**THE
NATIONAL
BOARD**
OF BOILER AND
PRESSURE VESSEL
INSPECTORS

NATIONAL BOARD SUBCOMMITTEE INSTALLATION

MINUTES

Meeting of July 15, 2015
Columbus, OH

FIGURE 3.7.5.1-c
HOT-WATER BOILERS IN BATTERY — ACCEPTABLE PIPING INSTALLATION

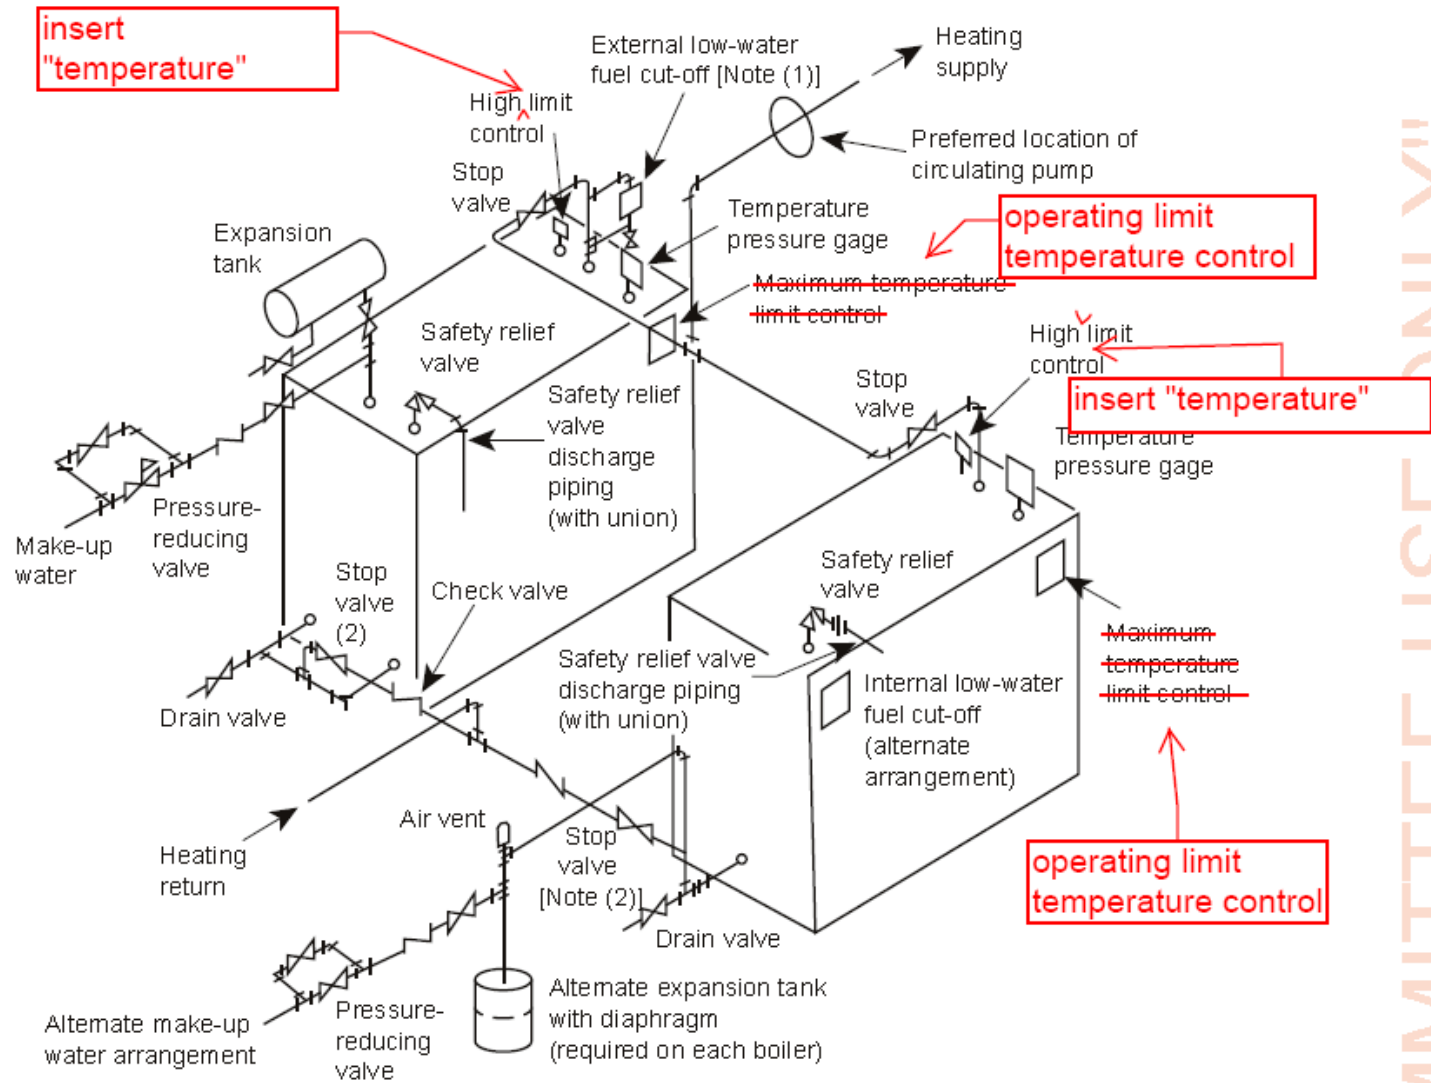
Part 1 Section 3.8.2.3 text and Figure 3.7.5-c callouts do not agree with each other and do not agree well with ASME Section IV HG-613 or ASME CSD-1 CW-400 in the labeling of operating temperature controls and high limit temperature controls.

The descriptive language among the NBIC, CSD-1, and Section IV are similar but not identical. The Figures in the NBIC and Section IV are in harmony. The figures do not, however, match the text. A similar suggestion to correct the callouts has been made to Section IV.

Figure HG-703.2
Hot Water Boilers in Battery - Acceptable Piping Installation

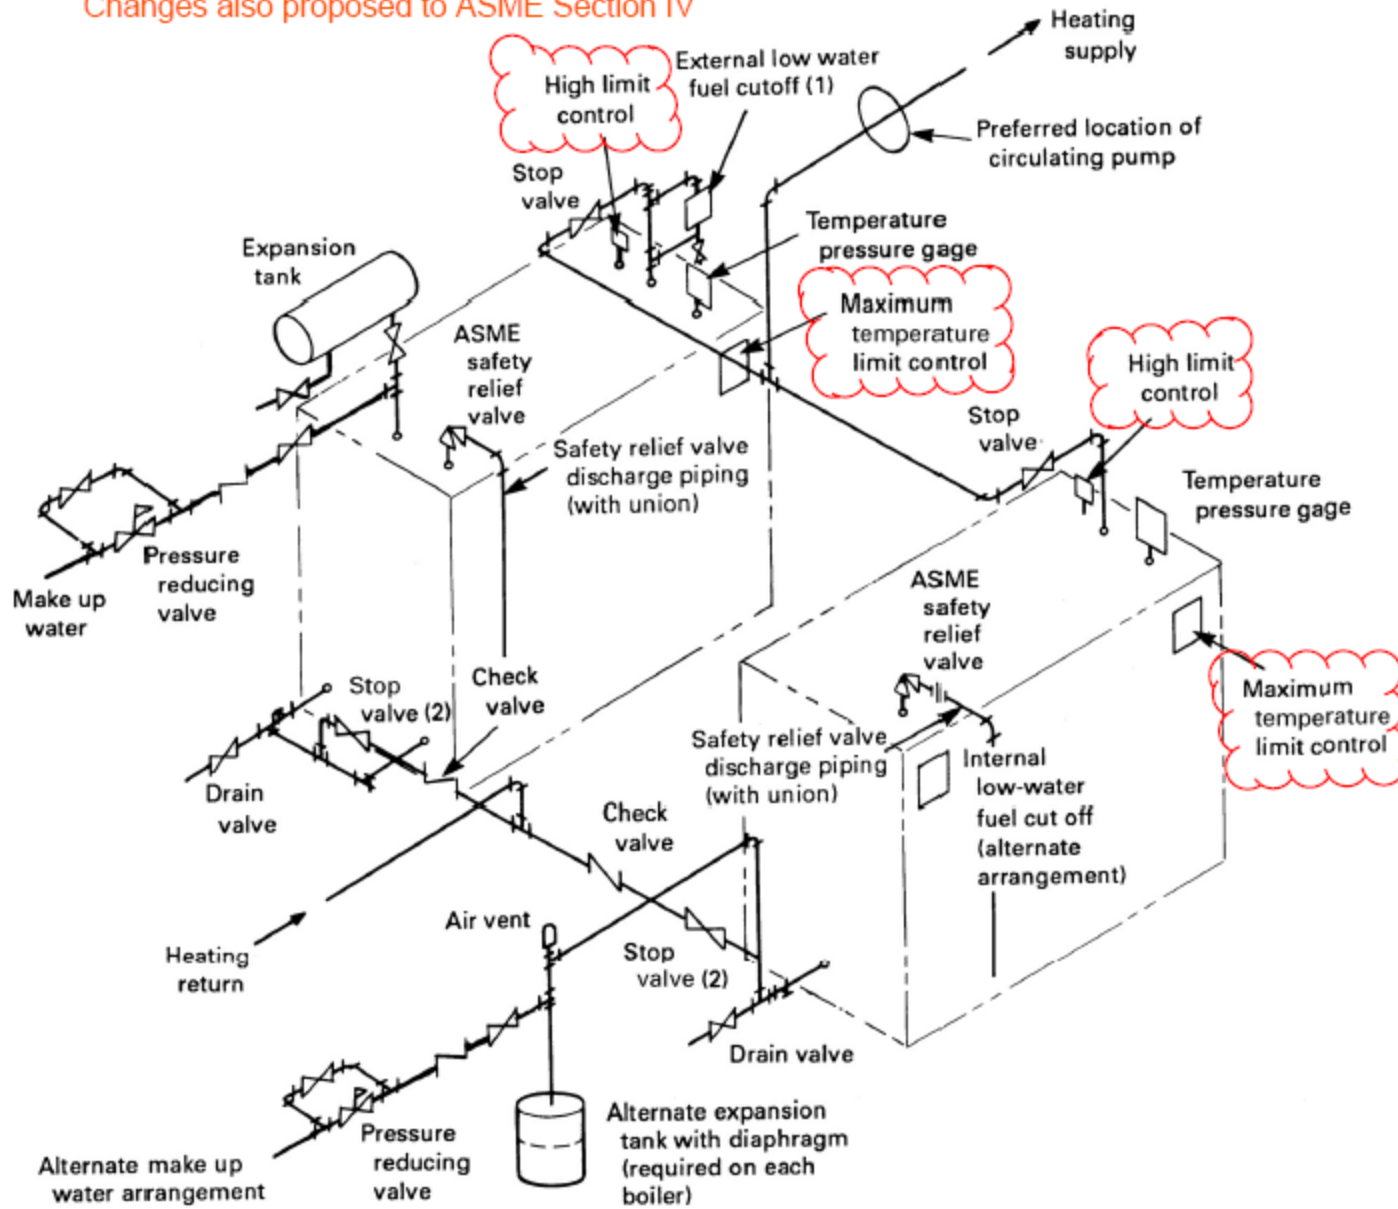
Changes also proposed to ASME Section IV
